INSTRUCTION MANUAL ADDENDUM

Page 9, step 1

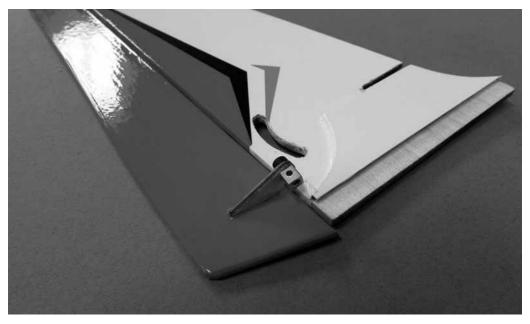
The screw-lock connector in the rudder horn illustrated in the instruction manual is mounted to the wrong side of the horn. Mount the screw-lock connector to the **bottom** of the horn as illustrated in this photo.
